WESTINGHOUSE ELECTRIC CORPORATION  
FOR  
CONSOLIDATED EDISON COMPANY  
INDIAN POINT GENERATING STATION - UNIT NO. 3

SCHEMATIC DIAGRAM  
DIESEL GENERATOR AUXILIARIES

SHEET NO. 14

U.E. & C. DWG. NO.  
9321-LL-31333

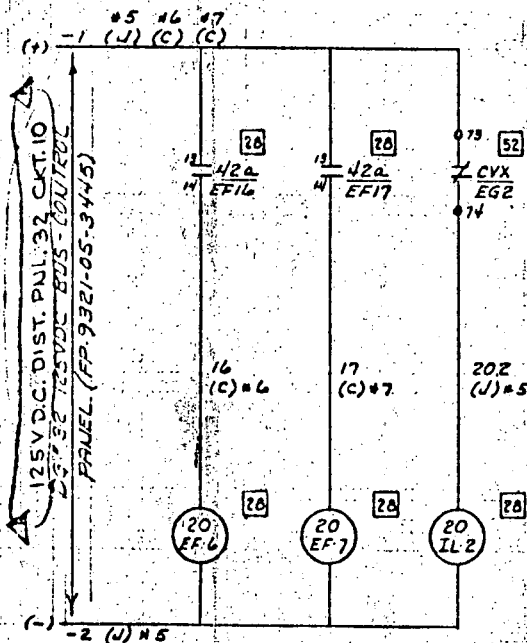
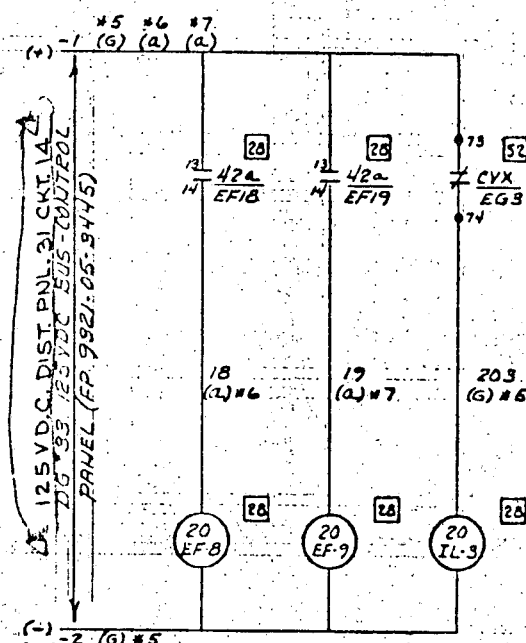
PER ITEM 1 OF EUP-367

2	11-74	REVISED PER ITEM 1 OF EUP-367		
3	13-72	ADDED (3) 125VDC SOURCES CBL (K) WAS (G) IN CH. II		
2	11-71	REV. TERM POINTS ON CVX CONTACTS		
1	11-71	ADDED CABLE LETTER REF. NOTES		
1	11-71	FIRST ISSUE FOR CONSTRUCTION		
2	DATE	DESCRIPTION	ENGR	SUP ENGR
ENGINEER		P. R. KILMOR		
STATE REG. NEW YORK		NO. 42453		
UNITED ENGINEERS & CONSTRUCTORS INC.
